# National Transportation Safety Board

## Response to Petition for Reconsideration

February 26, 2024

In accordance with Title 49 *Code of Federal Regulations (CFR)* 845.32, the National Transportation Safety Board (NTSB) has reviewed the petition for reconsideration and modification of the probable cause of the accident involving a Cessna 525 airplane in Memphis, Indiana, on November 30, 2018 (CEN19FA036). The petitioner has met the requirements for the NTSB's review of his petition; specifically, as the representative of Tamarack Aerospace Group, a party to the investigation, he has a direct interest in the investigation and has claimed that the NTSB's findings were erroneous. On the basis of its review of the petition, dated January 3, 2022, the NTSB grants the petition in part.

**Figure 1.** Witness marks on the side of the ram guide housing.

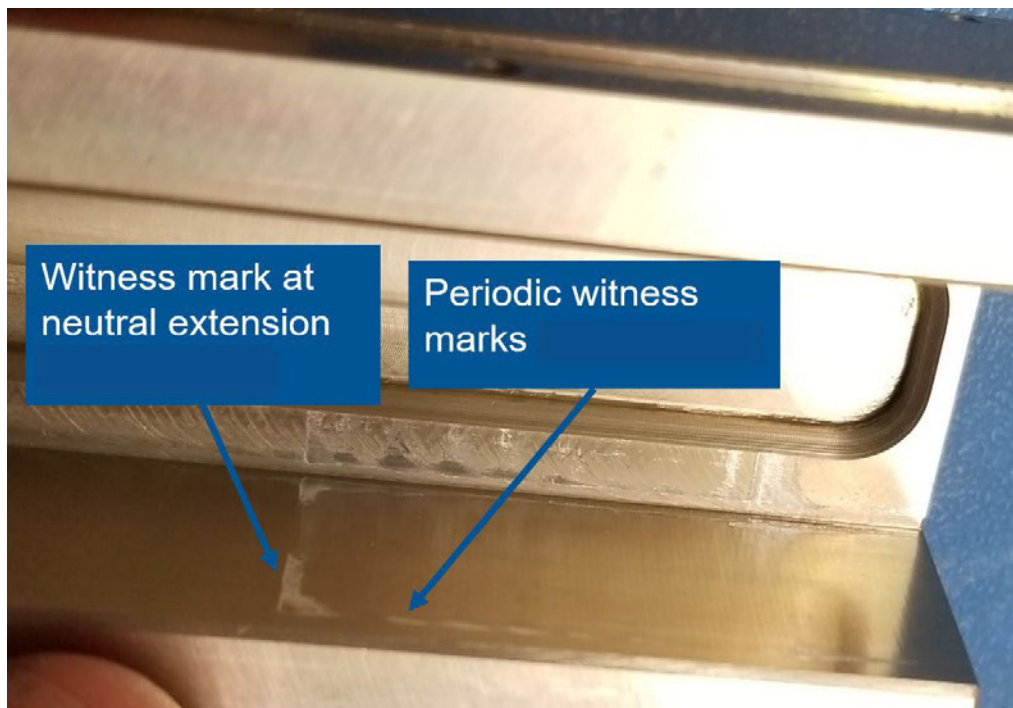
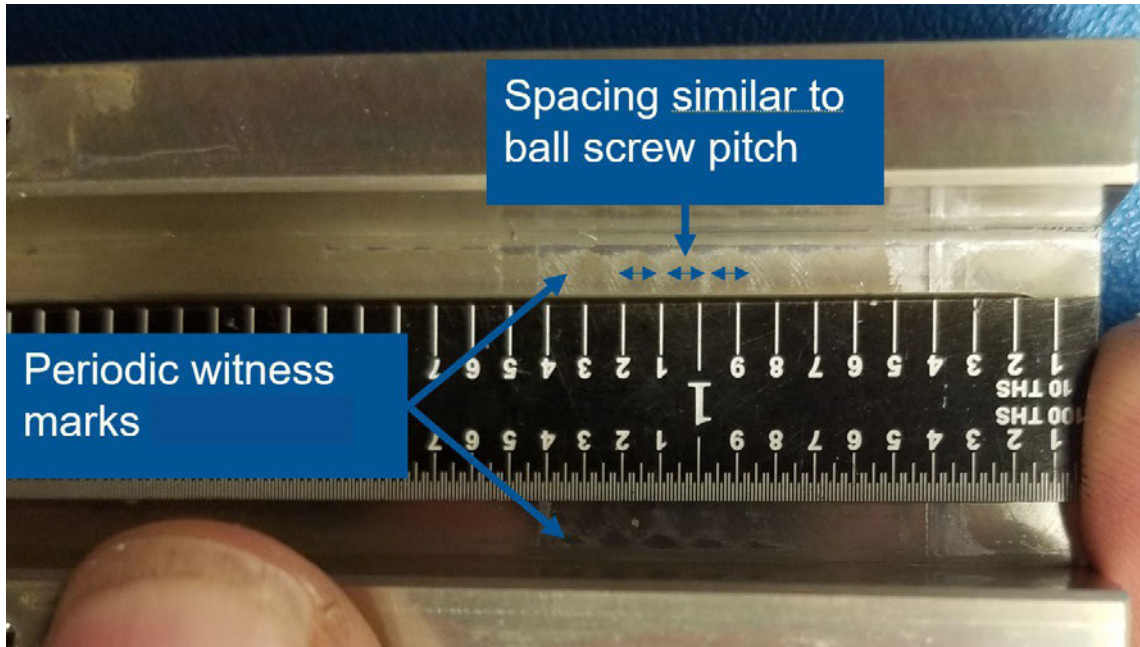
The NTSB's examination of the left TCU ram guide (as part of the original investigation) showed two sets of witness marks on the upper and lower surfaces; one set corresponded to the intermediate extension position of the actuator, and the other set corresponded to the full-extension position.<sup>7</sup> During the examination of photographs of the ram guide as part of this petition evaluation, the NTSB noted additional marks on one side of the ram guide.

The photographs in figures 1 and 2, which were taken after the grease was removed from the ram guide, show a mark that corresponds to a TACS neutral position of the actuator and periodic marks toward the TCU full-extension position; these marks were not discussed in the original report. The periodic marks were consistently spaced at the approximate distance of the pitch of the ball screw (which positions the TACS). It is possible that the ball screw deformed during impact and that subsequent motion of the ball screw could have caused nonlinear motion of the ball nut and the periodic contact marks on the sides of the ram guide.

In summary, the witness marks on the bellcrank and hinge were outside the normal range of travel and were likely not consistent with the TACS position at the time of initial impact. In addition, although the NTSB's original investigation found witness marks on the TCU ram guide at the intermediate- and full-extension positions, the NTSB's re-examination also found witness marks that corresponded to a TACS neutral position and periodic witness marks on the ram guide. As a result, the available evidence for this accident is insufficient to confirm the petitioner's assertion that the actuator was in an intermediate position at the time of initial impact. However, the NTSB agrees with the petitioner that the evidence is also insufficient to conclude that (1) the left actuator was in an extended position at the time of initial impact and (2) the ATLAS caused the left rolling moment; the NTSB has revised the report accordingly.

**Figure 3.** TCU bottom cover showing witness marks that corresponded to capacitor locations.

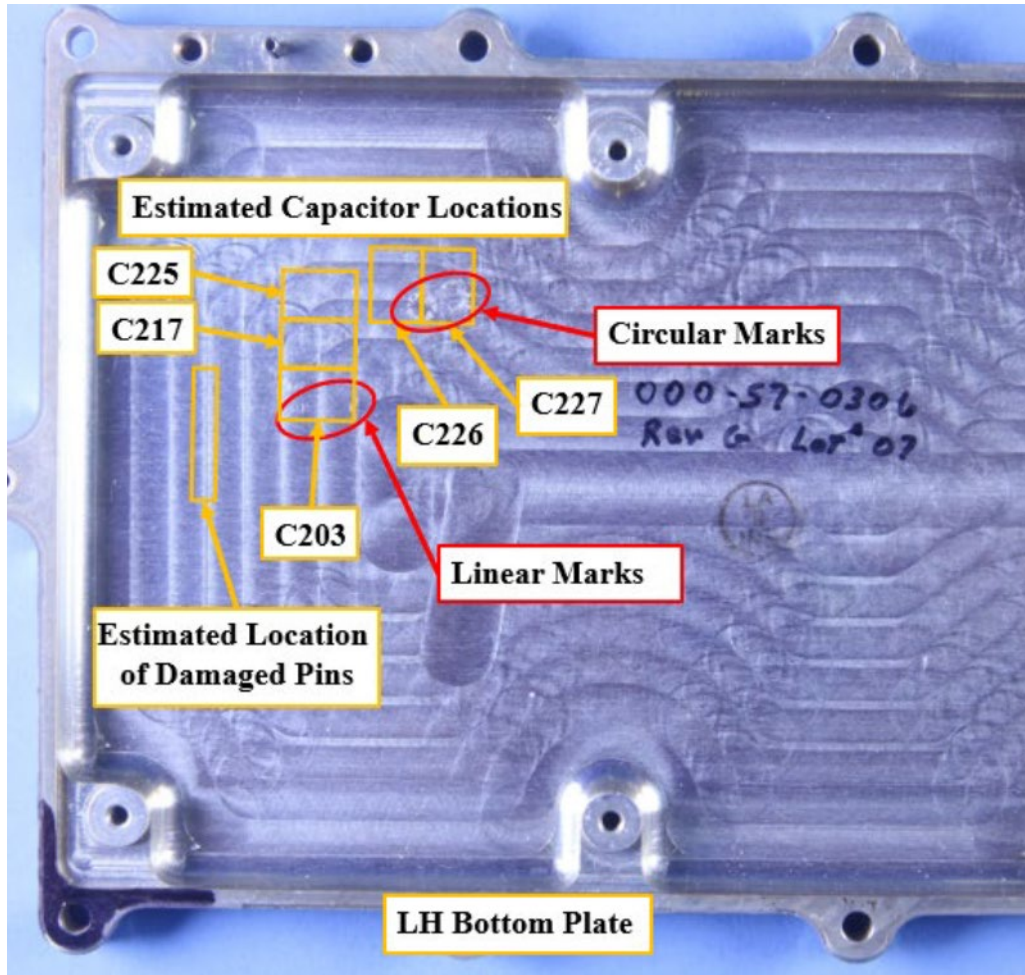
The NTSB’s original investigation found that 6 of the left TCU’s 40-pin electrical connector were bent (curled) but did not determine how or when those pins became bent. During our evaluation of the petition, the NTSB requested information from Tamarack about the deformation of the TCU circuit board under load. In response, Tamarack conducted impact load testing in spring 2023 and provided the results of to the NTSB. The testing showed that the TCU circuit board (on which the pin portion of the electrical connector was mounted) could deform under loads and that impact forces could have, at a minimum, partially separated the connector pins, resulting in damage to the pins.

Figure 3 is a photograph (from the original investigation) of the bottom cover of the TCU. The figure shows that witness marks had transferred from the TCU circuit board to the bottom cover, which could have only occurred if the circuit board flexed until it contacted the cover. These marks were not noted in the final report for this accident.

Dimensional analysis of the circuit board assembly (performed by the NTSB as part of this petition evaluation) showed that, if the circuit board deflected during impact so that it contacted the bottom cover of the actuator, and if the bottom cover deflected slightly, the pins could disengage from the connector.<sup>10</sup> The analysis also showed that the area of maximum deflection of the circuit card was in line with the area of the 6 bent pins, which could explain why only 6 of the 40 pins were affected.

The NTSB found that the additional information from the impact load testing and dimensional analysis supported the possibility that the pins became bent during impact. However, the additional information does not eliminate the possibility that the pins had become bent during manufacture or maintenance given that the pins' pre-accident status is unknown.
